Location:	2424 Webster Street (See map on reverse)
Assessor's Parcel Numbers:	008-0656-004-00 & -001-00
Proposal:	Design Review discussion for a proposed development that would include an 11-story commercial building containing approximately 162,000 square feet of office space and approximately 9,500 square feet of ground floor retail.
Applicant:	Elisse Douglass/ Signature Development Group
Owners:	2410 Webster Investors LLC
Planning Permits Required:	Regular Design Review for new construction, Major Conditional Use Permit for D-BV-1 height bonus and to extend building height into adjacent zone.
General Plan:	Central Business District
Zoning:	D-BV-1 (BVDSP Retail Priority Site 3C) D-BV-2
Environmental Determination:	Determination Pending
Historic Status:	2428 Webster Street – OCHS Rating: Ec3 2406 Webster Street – OCHS Rating: C3
City Council District:	3
For further information:	Contact case planner Pete Vollmann at (510) 238-6167 or by email: pvollmann@oaklandca.gov .

SUMMARY

CITY OF OAKLAND PLANNING COMMISSION

Case File: PLN19148
Applicant: Elisse Douglass/ Signature Development Group
Address: 2424 Webster Street
Zone: D-BV-1 (BVDSP Retail Priority Site 3C), D-BV-2
Height Area

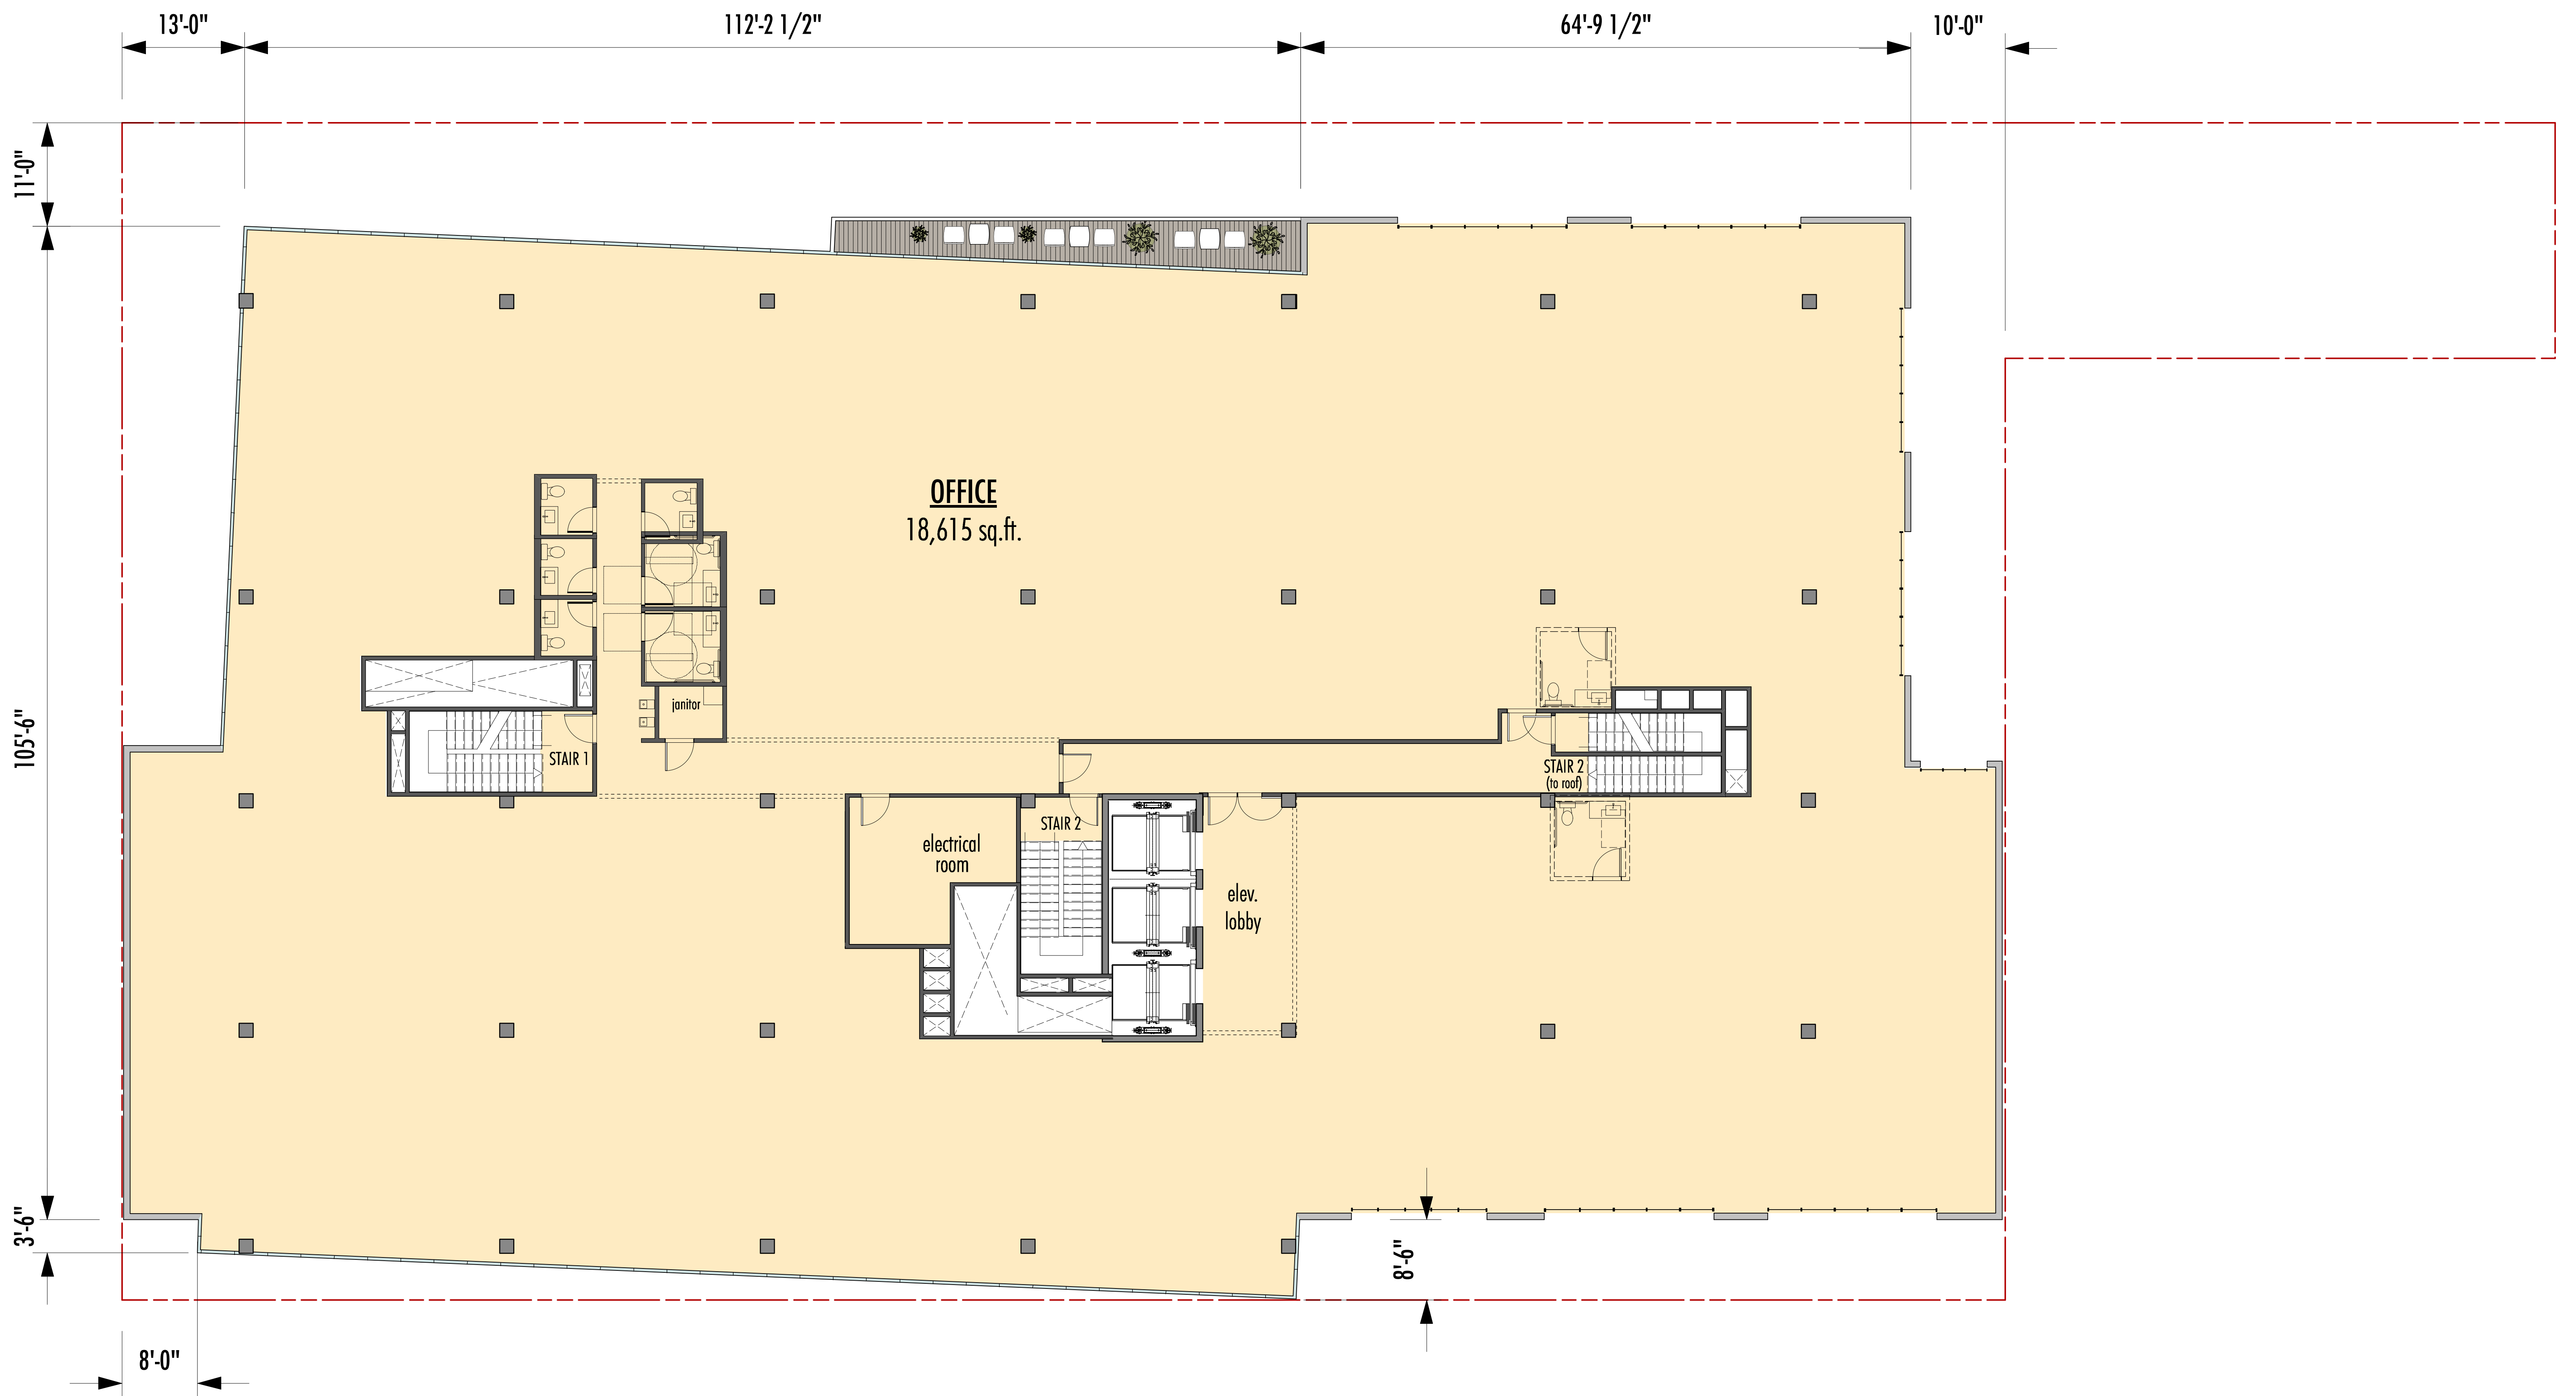
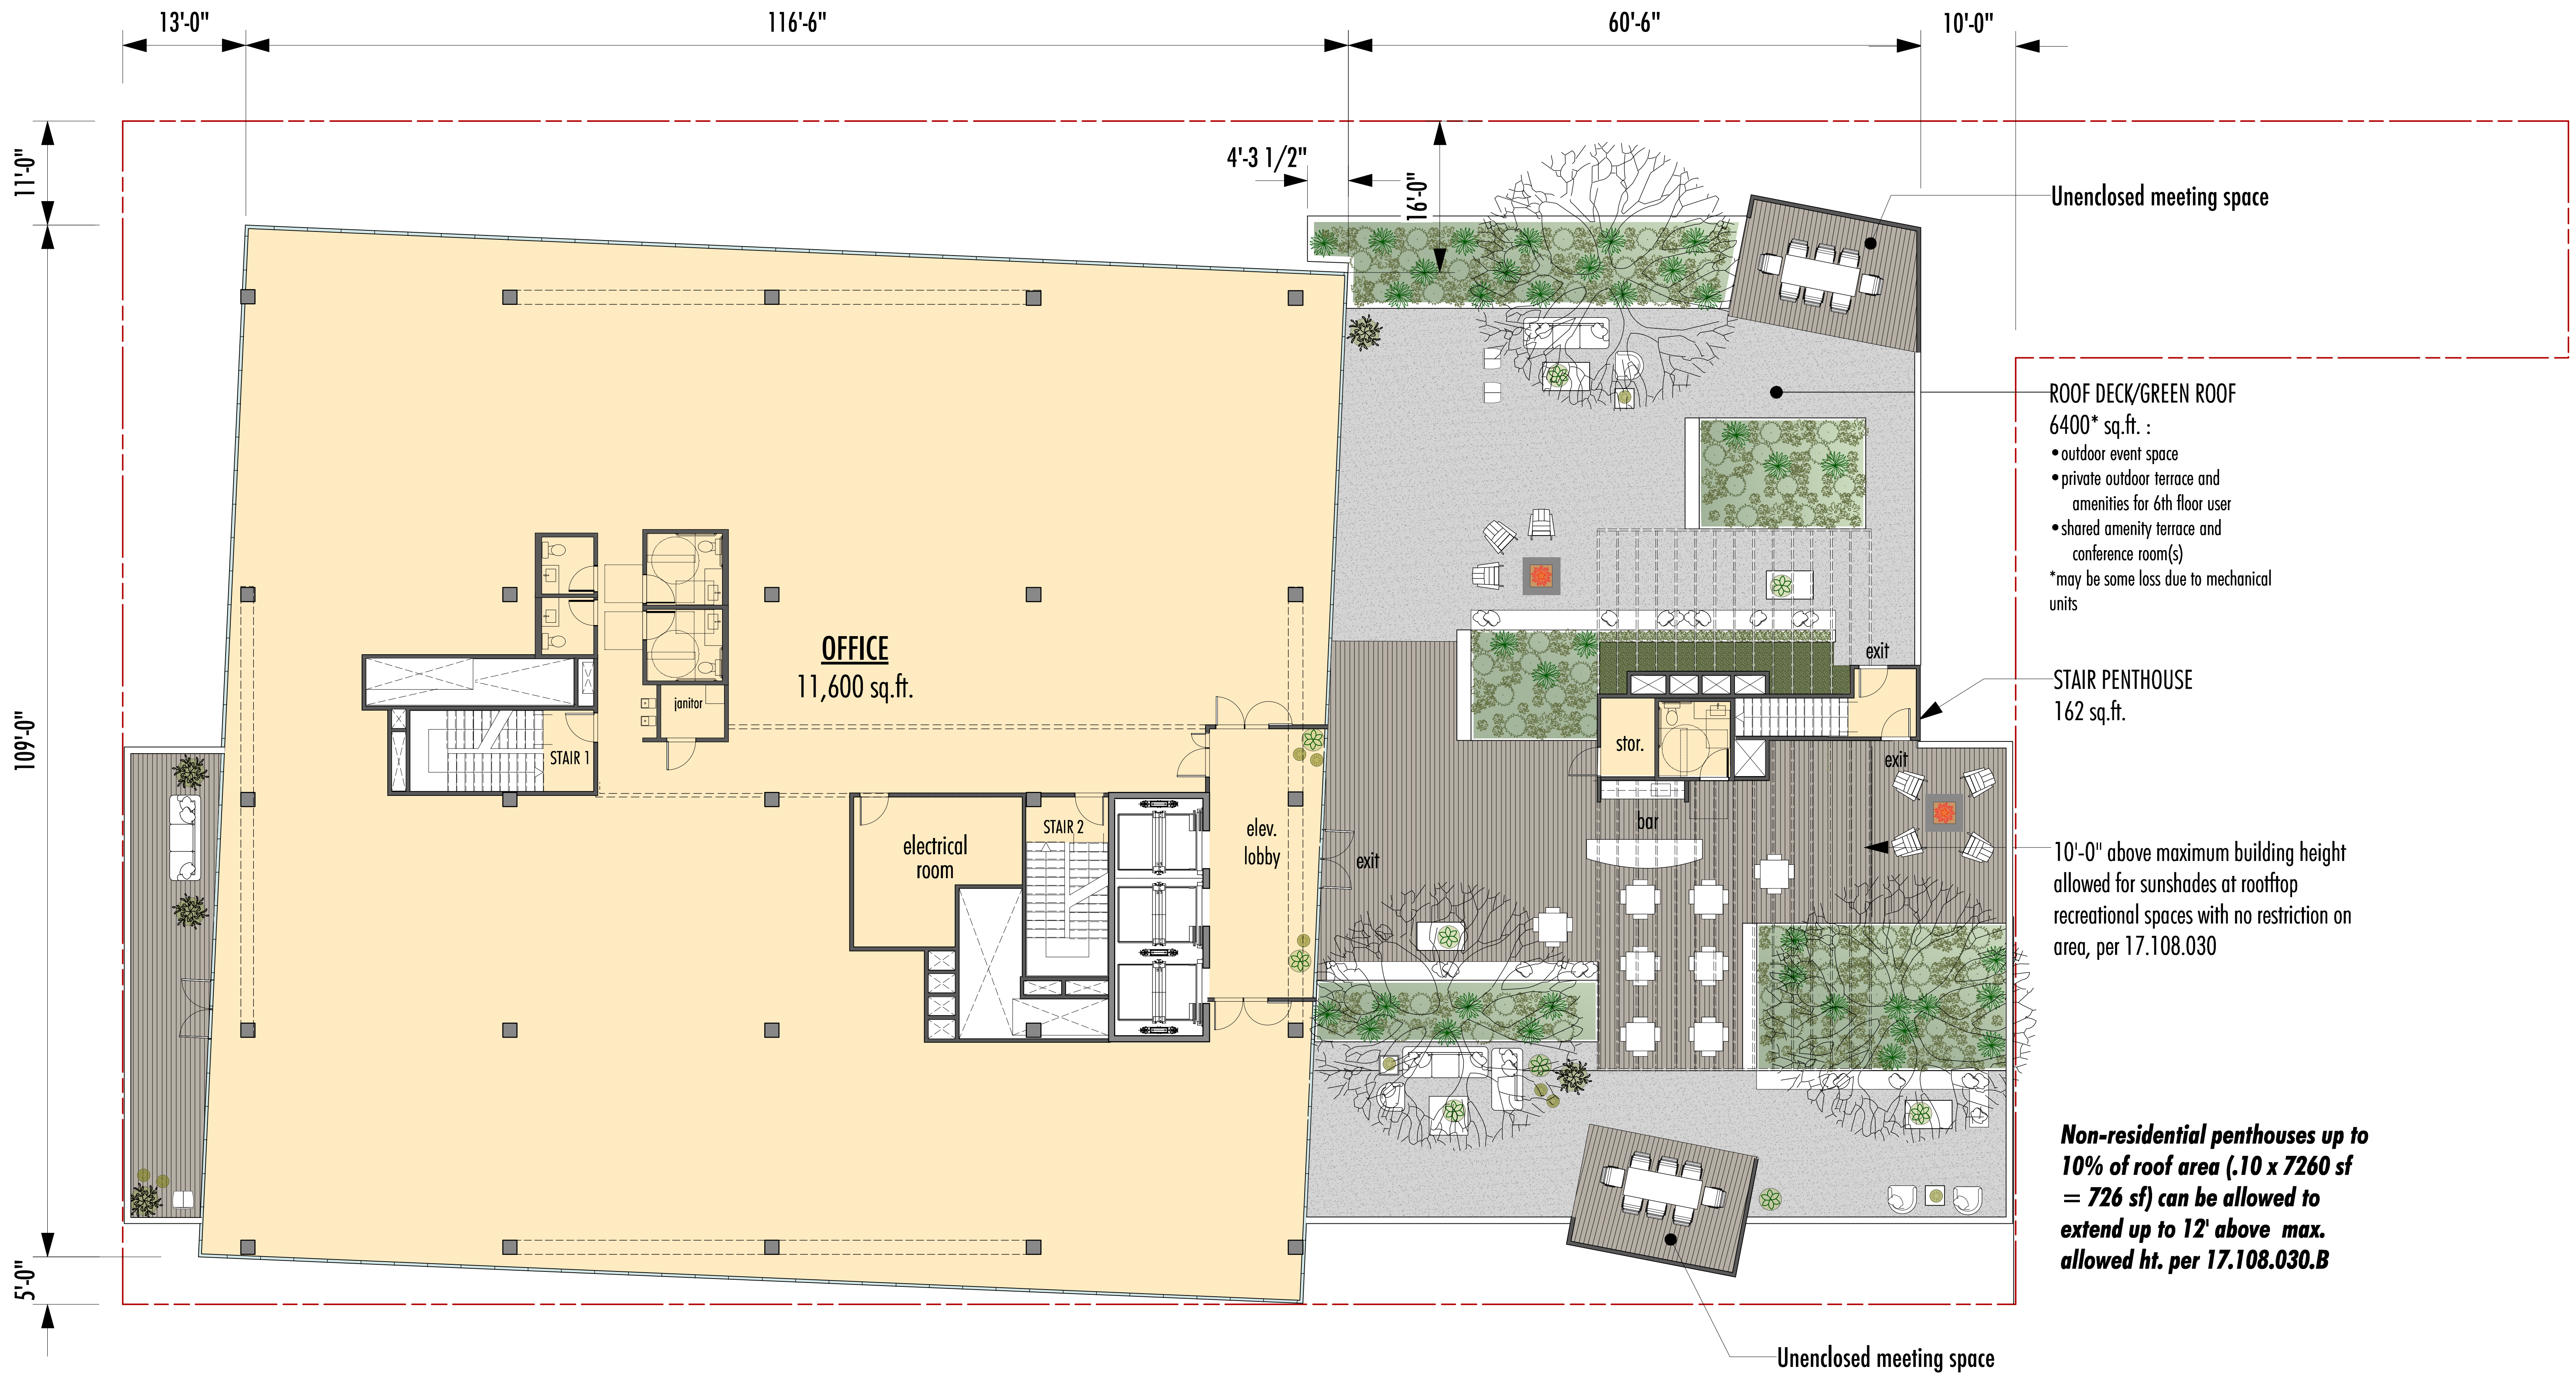
While the design of the proposed 11 story tower has an interesting design concept with the alternating floor plates that project and recede, they result in a very horizontal building façade. The Broadway Valdez District Design Guidelines (Guideline 41) recommends that building elevations contain visual breaks in the massing, in approximately 25-50 foot sections, in order to break down the horizontal planes of building facades. Staff recommends that the applicant look into ways that they can still achieve the design aesthetic with the alternating floor plates while incorporating a vertical break along the façade to break down the visual mass of the tower.

Staff also recommends that the applicant look into adding a more defined top to the building either through a well designed parapet that can add to the prominence of the top floor (as well as screen the rooftop mechanical equipment), or look into using a design feature that pulls the the top two floors into a similar building form to enhance the visual top of the building.
